Access Compliance Report

Public Rights-of-Way

(Curb Ramps)

Intersection ID: 12632	Main Street: SEIGLE_AV	Cross Street: SKYLINE_VIEW_WY	Location: W
ADA ID: E6951A5AFD25	Ramp Type: Directional1	Initial Pass/Fail: Pass	Overall Compliance: No
Severity Score: 7.75			
Codes/Mitigation Info/Possible Solution		Field Measurements/Component Compliance

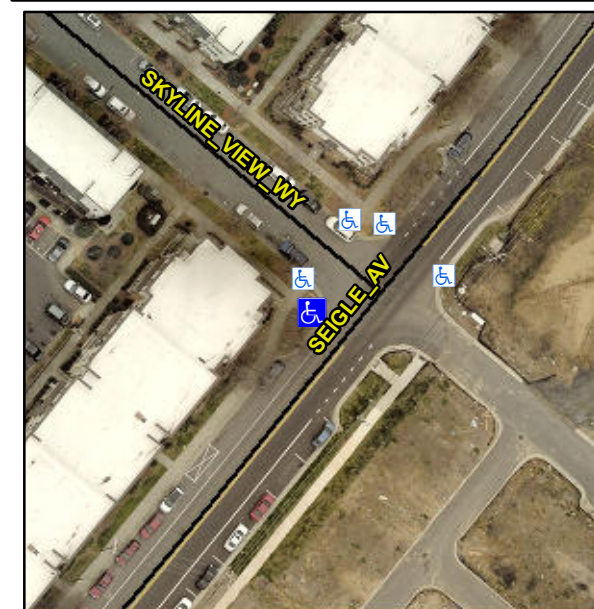
Remove & Replace Landing. Grind Gutter Lip.

R304.5.3, R302.7.2
